**DIAMOND HILL
COMMUNITY DEVELOPMENT DISTRICT**

POND INSPECTION REPORT

Technical Memorandum

Project Name: SWFWMD ERP Permit Report

1100

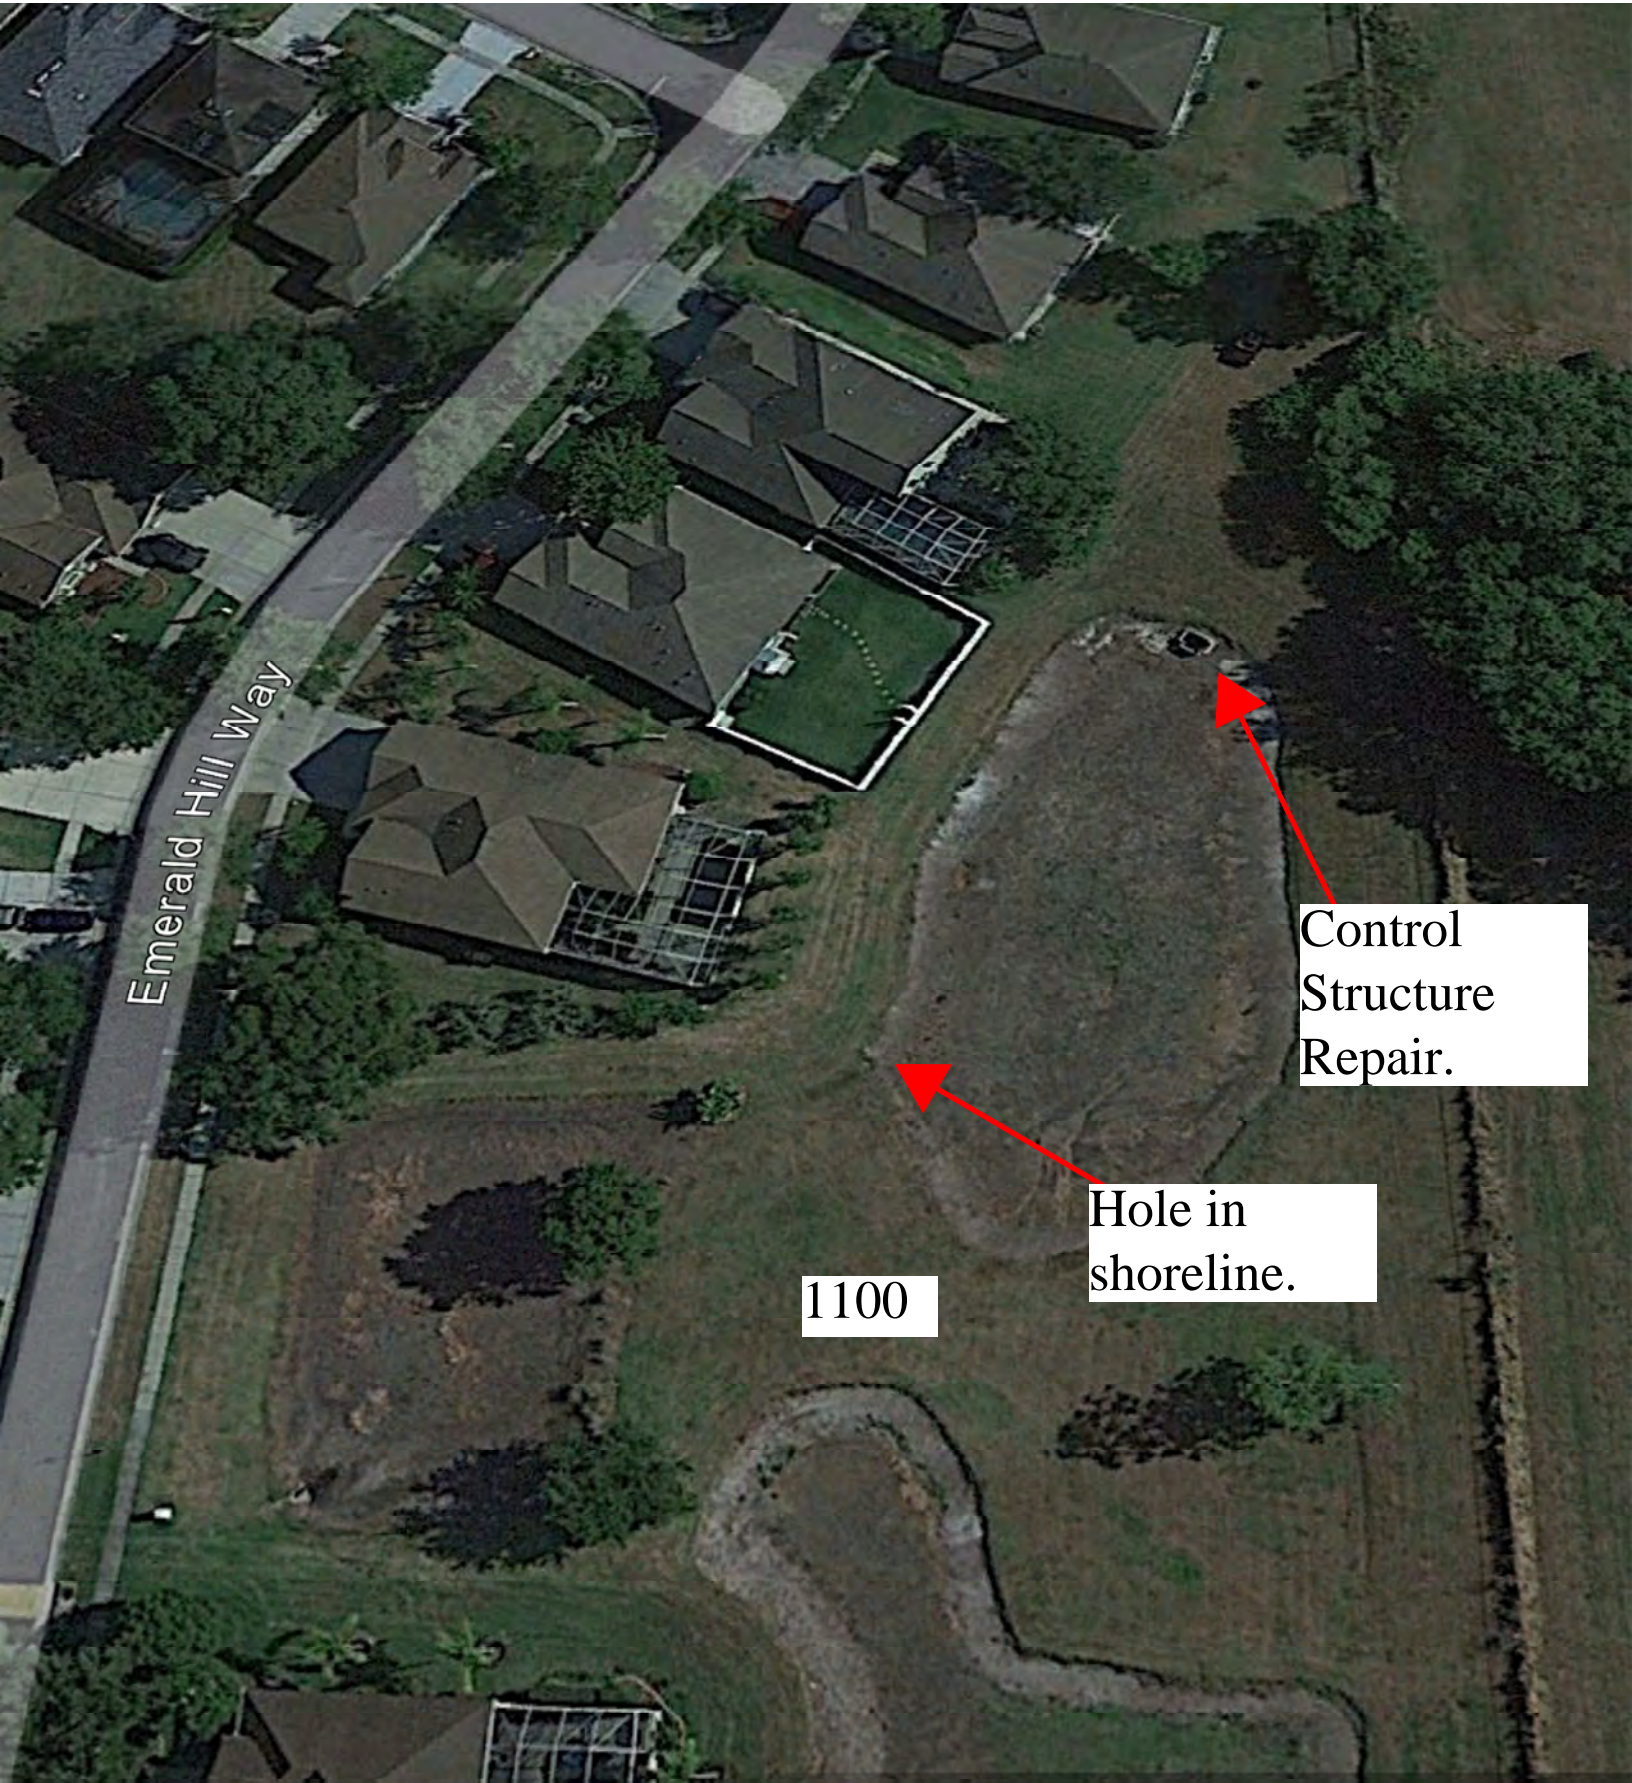
Bank Erosion Notes: There was a section of pond bank observed to have a large hole of undermined turf on the West side of the Northern most pond that should be investigated further.			
CONDITION OF POND STRUCTURES (CONTROL STRUCTURES, MITERED END SECTIONS, INLETS)			
Severity Ranking:	Moderate		
Type of Damage:	Control Strutre Repair		
Structures Notes: The control structure in the northern most pond was observed to have a broken grate boarder. The piece is mangled and jutting off the structure. There is also broken off concrete from the structure with exposed skimmer mounting hardware behind. Two FES were observed in operational condition with no defects.

Hole in shoreline.

Control Structure Repair.

1450

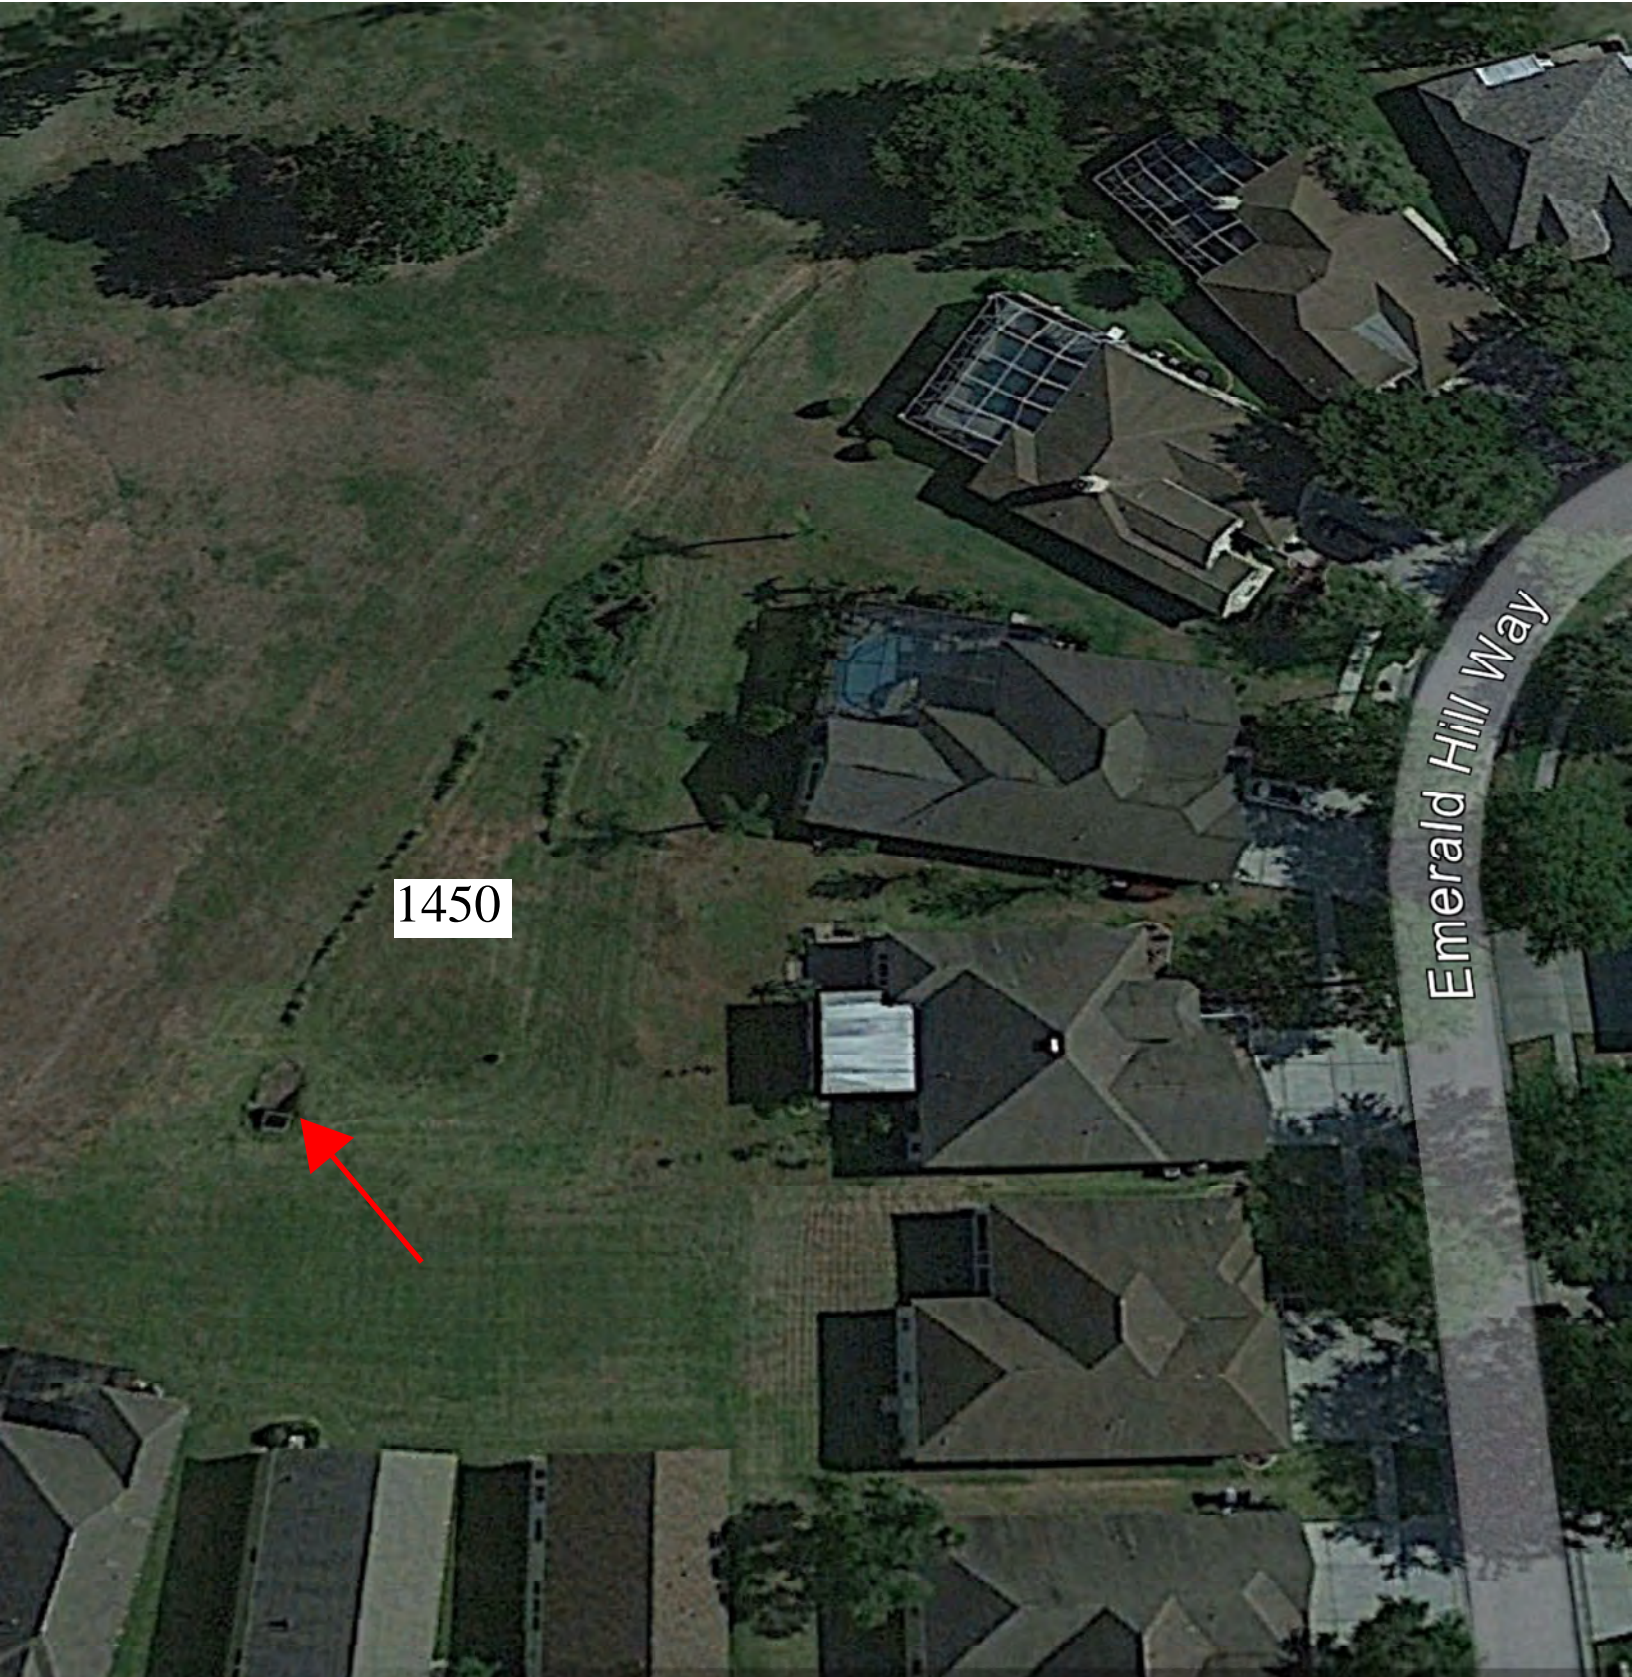
Minor erosion behind control structure

Exposed hardware.

CDD POND EVALUATION			
INSPECTION DATE:	1/11/2024	PERMIT NUMBER:	24679.003
INSPECTED BY:	Jerry Whited	POND PERIMETER:	398 ft
POND NUMBER:	1450	POND AREA:	6,744 sq ft
Full Pond Access:	Yes	Trash Observed:	No
Beneficial Vegetaion Present:	NA	Water Quality:	NA
Tailwater Issue Observed:	No	Water Quality Notes:	Dry Pond
Observed Depth:	NA	Observed Temperature:	NA
POND ELEVATION ANALYSIS			
Treatment Type:	Dry (NA)	Design Bottom Elevation:	110
Weir/Orifice Elevation:	110	Observed Elevation:	110
Skimmer Bottom Elevation:	109.5	Elevation Difference:	0
Pond Elevation Notes: This is a dry pond.			
BANK EROSION AND SCOUR			
Severity Ranking:	NA		
Type of Erosion:	None		
Bank Erosion Notes: Dry Pond - no erosion or shoreline defects observed.			
CONDITION OF POND STRUCTURES (CONTROL STRUCTURES, MITERED END SECTIONS, INLETS)			
Severity Ranking:	Minor		
Type of Damage:	Skimmer Repair		
Structures Notes: One control structure observed with a skimmer that has connection hardware that has failed. Hardware should be replaced on skimmer. One FES observed in operational condition with no defects.

1500

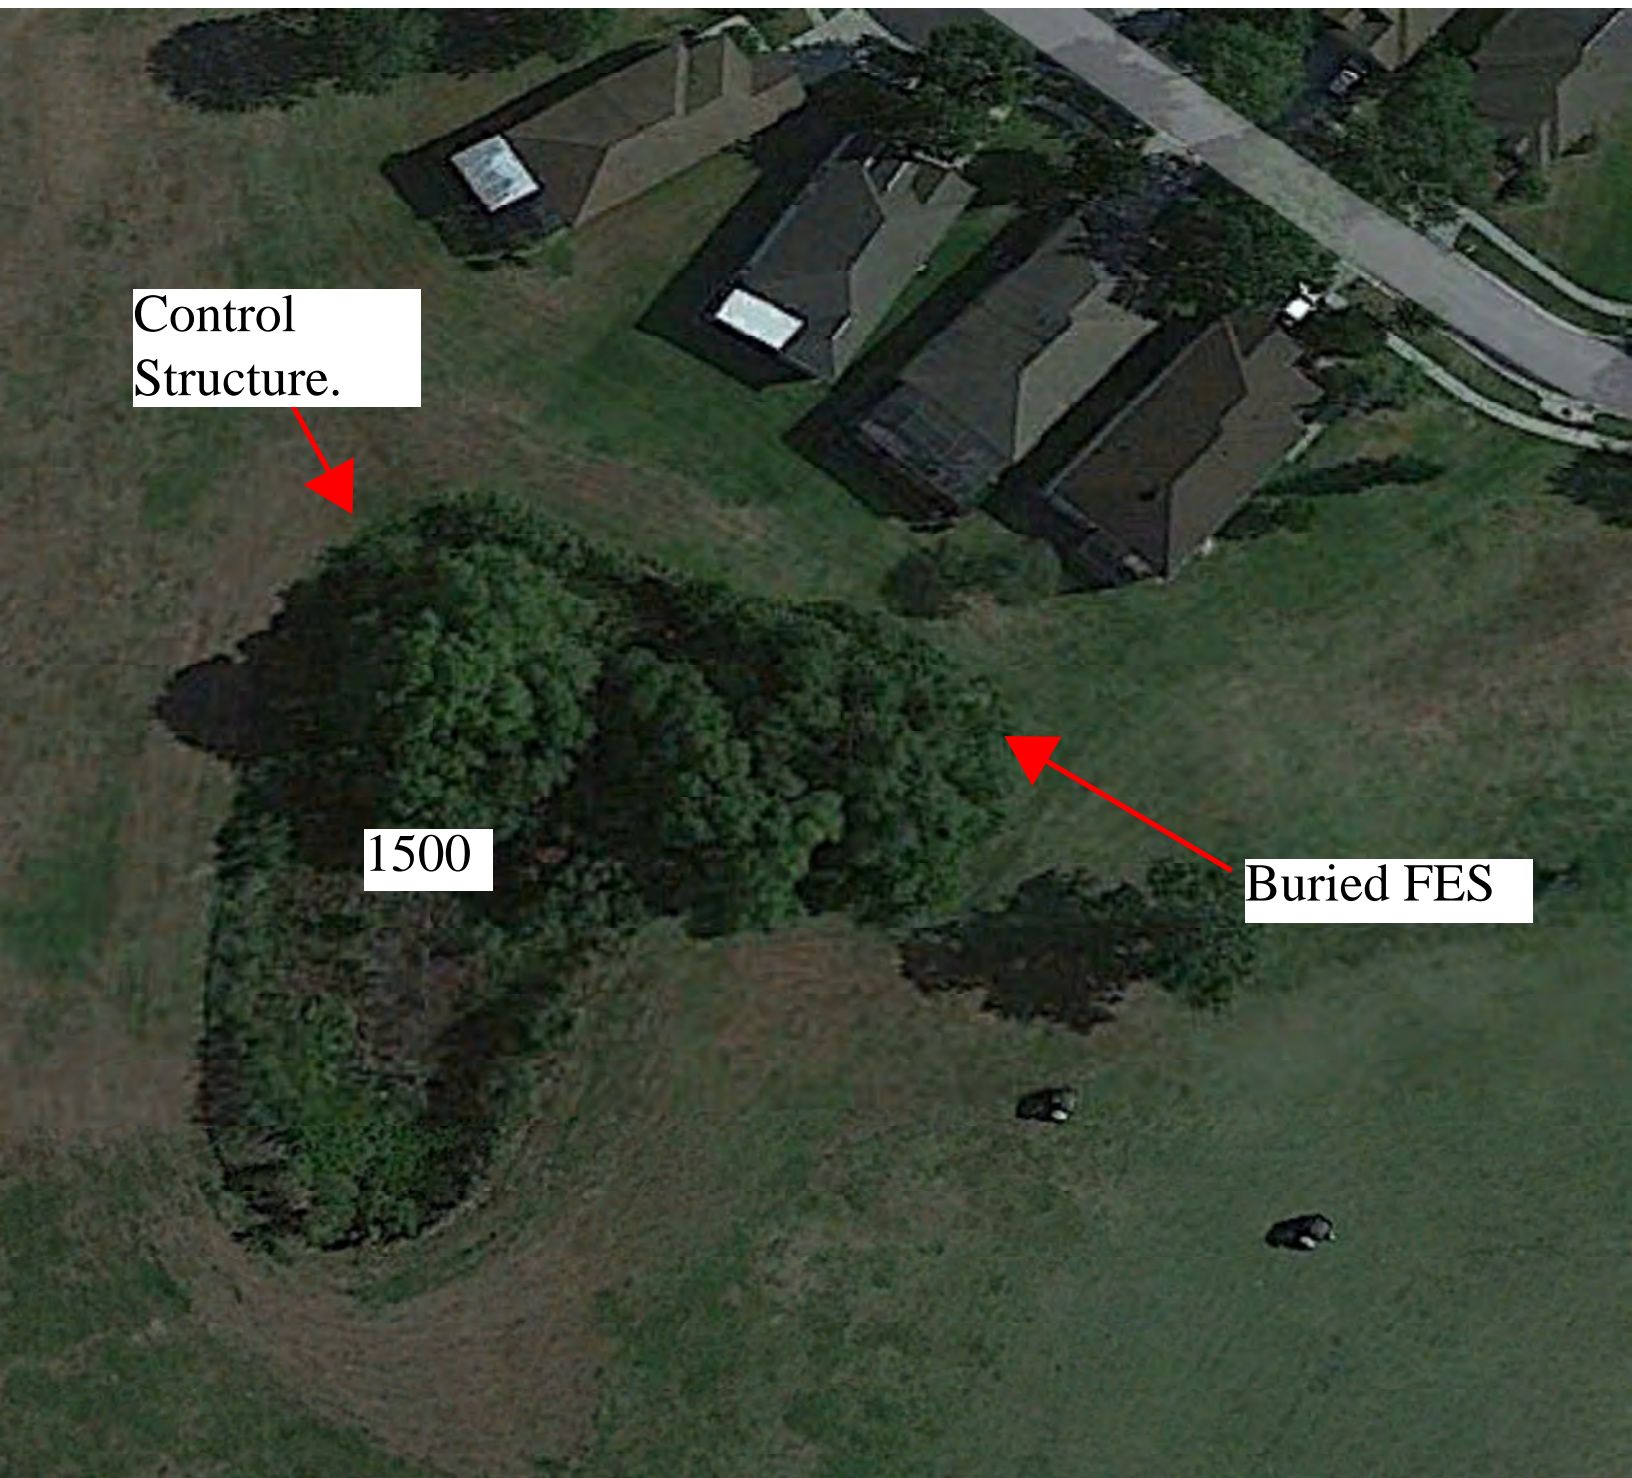
CDD POND EVALUATION			
INSPECTION DATE:	1/11/2024	PERMIT NUMBER:	24679.003
INSPECTED BY:	Jerry Whited	POND PERIMETER:	620 ft
POND NUMBER:	1500	POND AREA:	21,733 sq ft
Full Pond Access:	Yes	Trash Observed:	Yes
Benifitial Vegetaion Present:	Np	Water Quality:	NA
Tailwater Issue Observed:	No	Water Quality Notes:	NA
Observed Depth:	0	Observed Temperature:	NA
POND ELEVATION ANALYSIS			
Treatment Type:	Dry Filter	Design Bottom Elevation:	100
Weir/Orifice Elevation:	102.1	Observed Bottom Elevation:	100
Skimmer Bottom Elevation:	101.6	Elevation Difference:	0
Pond Depth Notes: This is a dry pond.			
BANK EROSION AND SCOUR			
Severity Ranking:	NA		
Type of Erosion:	None		
Bank Erosion Notes: Dry pond. No erosion or shoreline defects observed.			
CONDITION OF POND STRUCTURES (CONTROL STRUCTURES, MITERED END SECTIONS, INLETS)			
Severity Ranking:	Moderate		
Type of Damage:	FES covered and concrete failing.		
Structures Notes: FES on NE side of pond appears to have been covered up or buried by debris. There is a need to uncover the FES to avoid issues with the curb inlets flooding the adjacent streets. Historical records show this pond was not overgrown like this until after 2016. One control structure observed to have cracks in the concrete and skimmer hardware is completely exposed on one side. Vegetation must be cleared to provide access to MES & Control Structure. Recommend full pond quarterly maintenance.

Control
Structure.

Buried FES
